SP2020-002

Lot 10, Blk A, Whitmore Drive

Project Plan Review History

SP2020-002; 855 Whitmore Drive

ELEVATION TOWNSEND MEDICAL OFFICE ROCKWALL, TEXAS

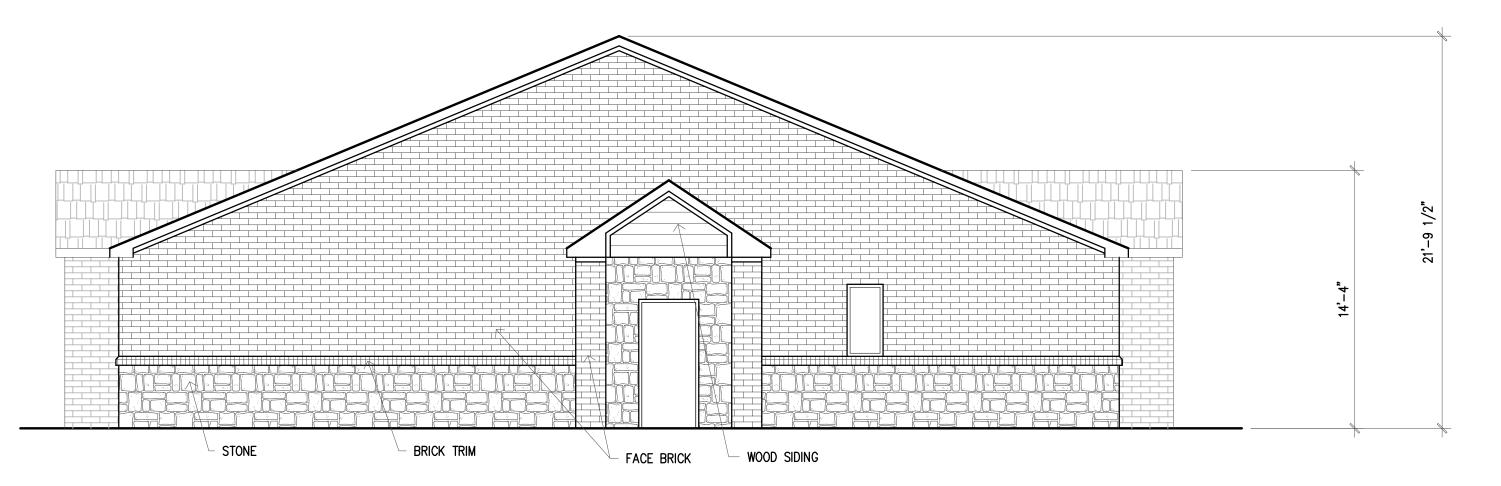
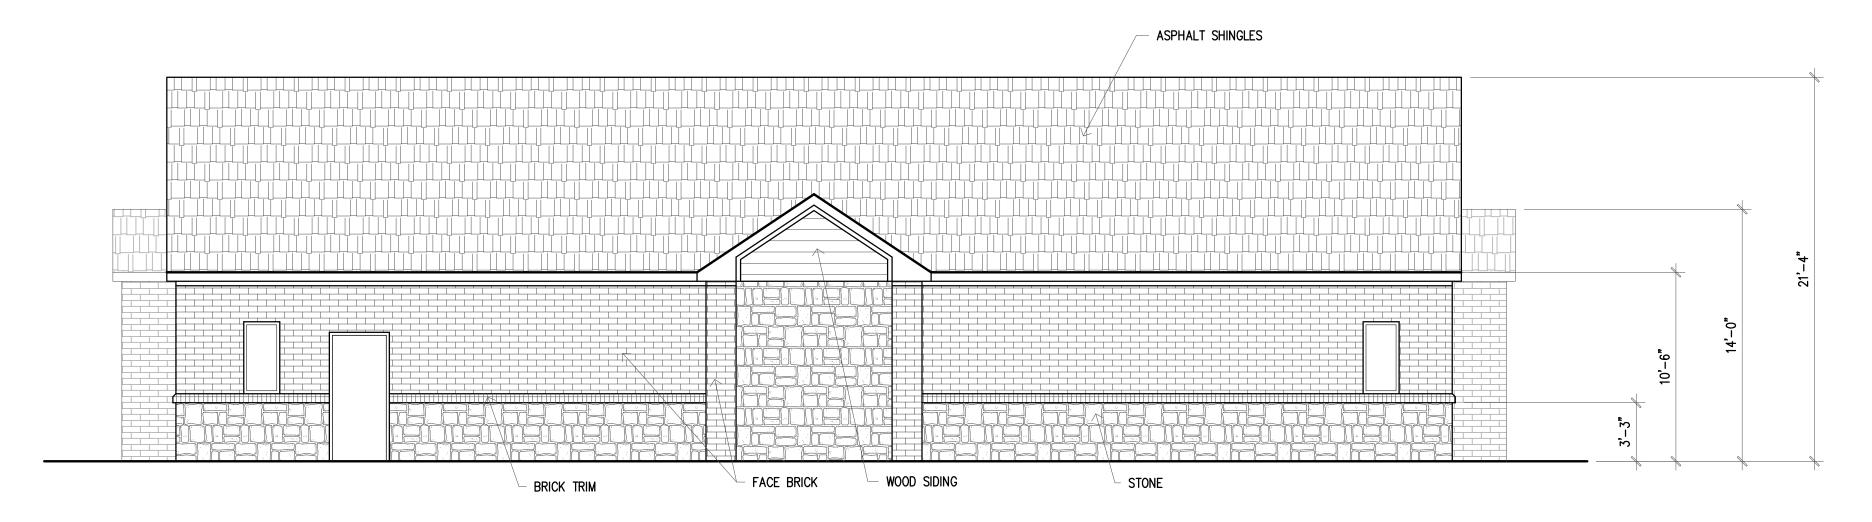
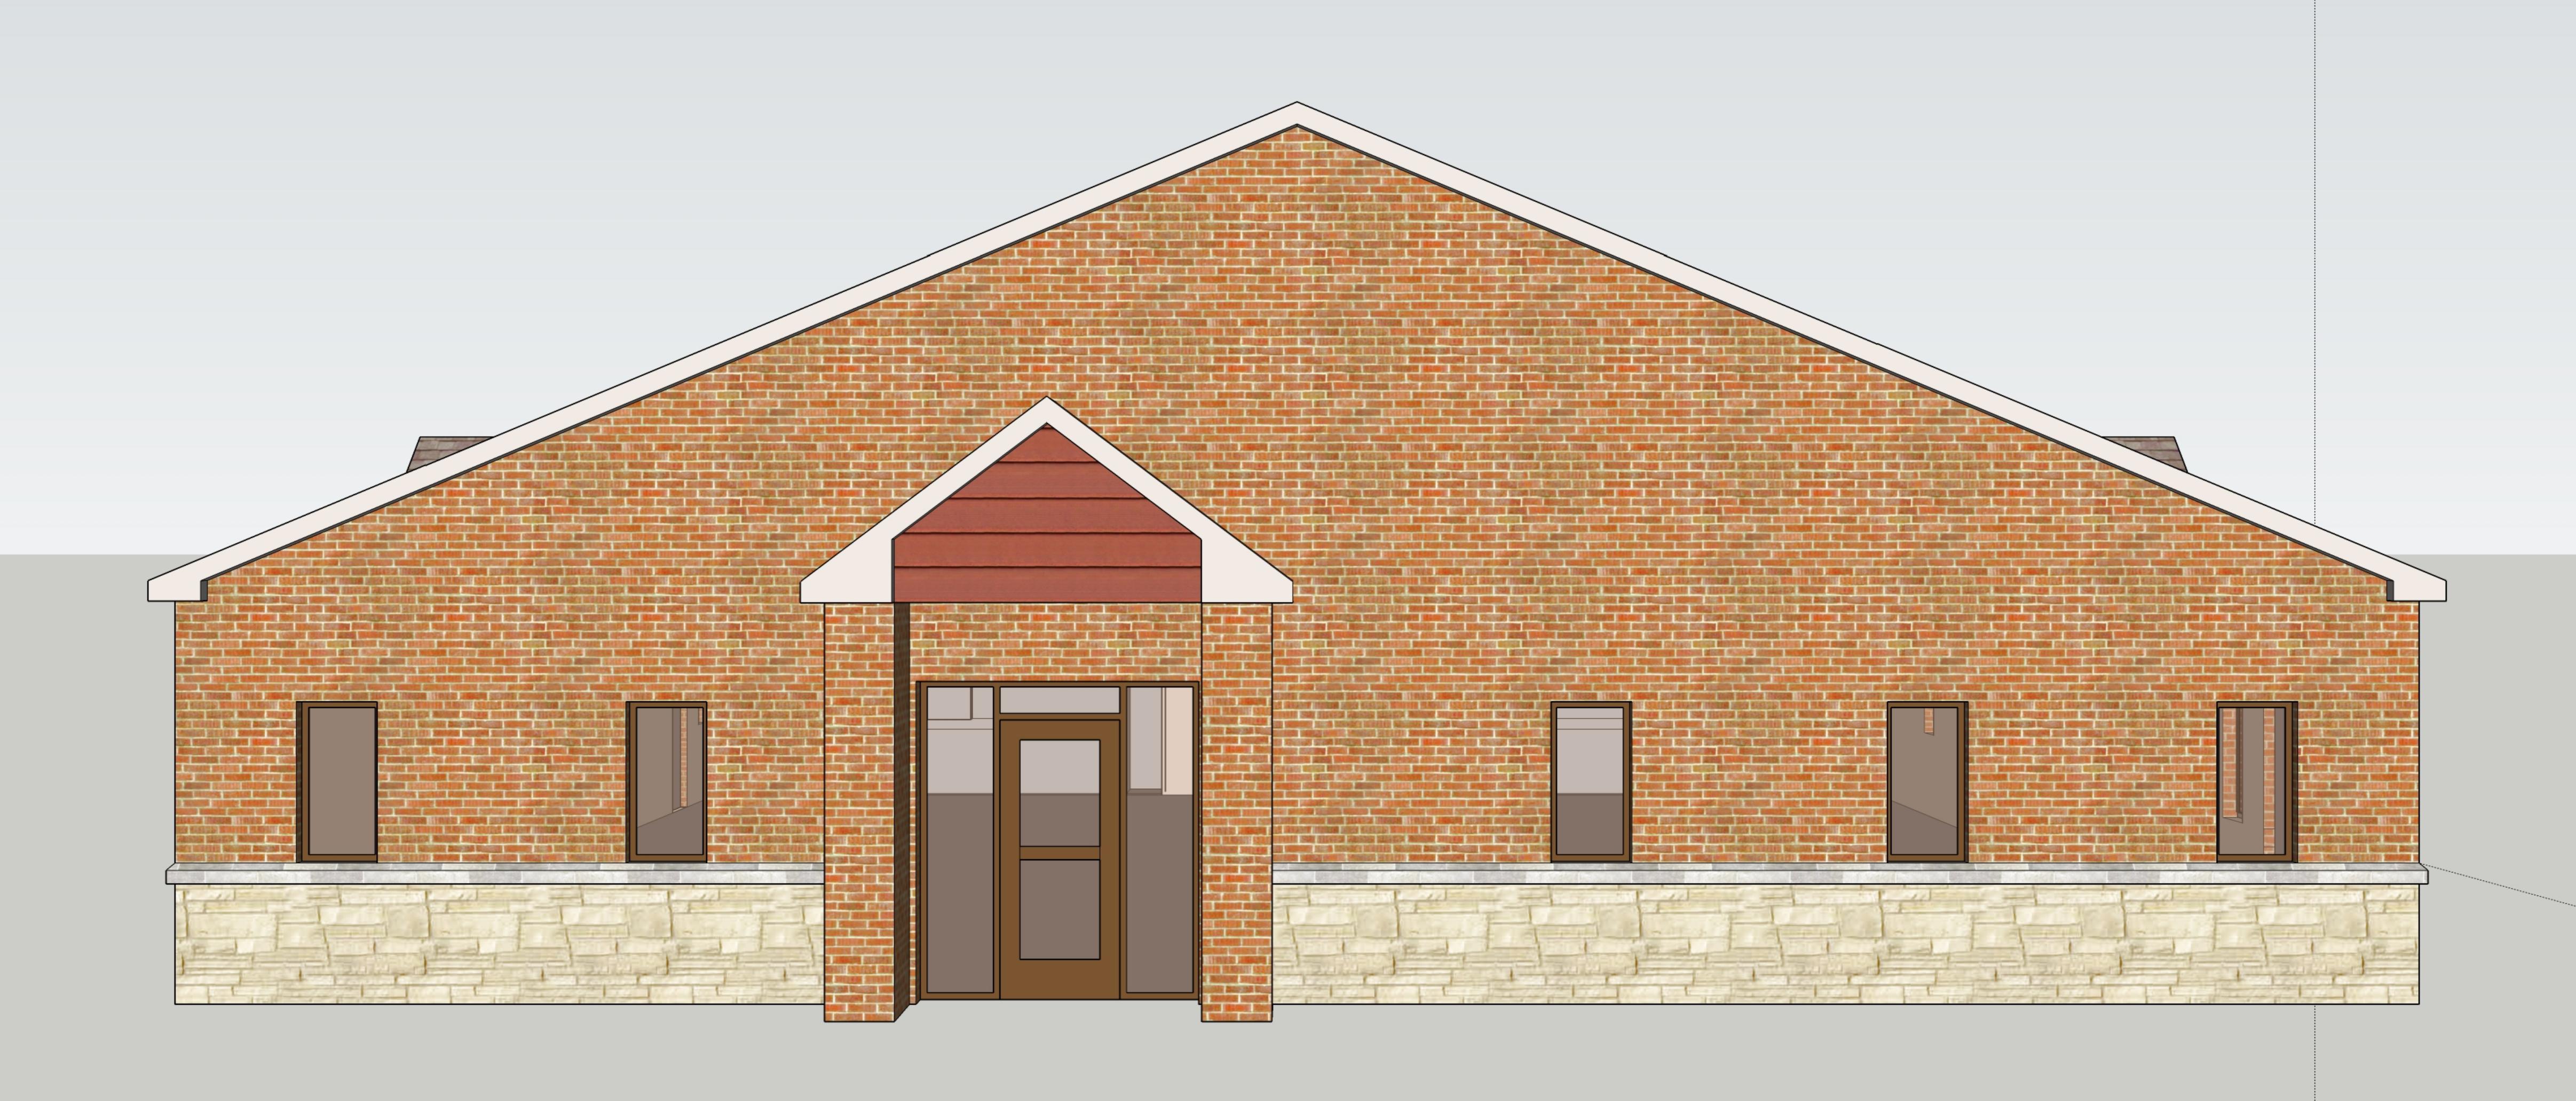
- 1) Please consider using an alternate material (i.e. wood beams) for the smaller gables
- 2) Please consider removing/revising the projecting elements on the North and South building elevation. As drawn, it does not meet articulation standards.

- 3) Please review Section 6, Industrial Districts, of Article 5, District Development Standards of the UDC.
- 4) Please consider removing the stone above the door on the East Elevation

- 5) Since the entryways are not symmetrical, please consider a squared-off entryway instead of the pitched roof.
- 6) Please consider
- 7) Please provide all 4 sides of the dumpster enclosure.

- 8) Please consider different windows that are proportionate to the building size
- 9) Pleaseshow door swing on the doors
- 10) Please note, the window on the South Elevation is at a different height than the remaining windows

- 11) Please consider adding additional windows/architectural elements to the South and West Elevations
- I.6 Please note that failure to address all comments provided by staff by5:00 PM on February 4, 2020 will result in the automatic denial of the case on the grounds of an incomplete submittal No refund will be given for cases that are denied due to an incomplete submittal and a new application and fee will be required to resubmit the case.

PLAN

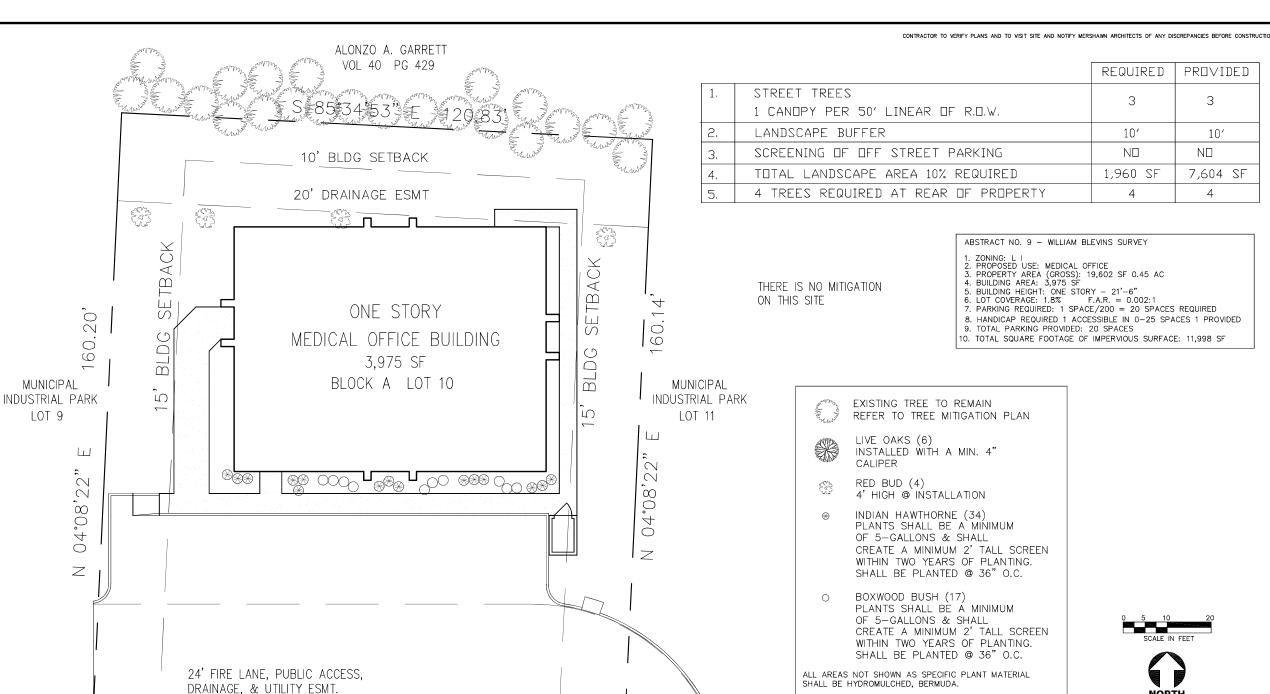
Trees will be

water service

connections.

on top of

All ROW to be sodded.

Add note.
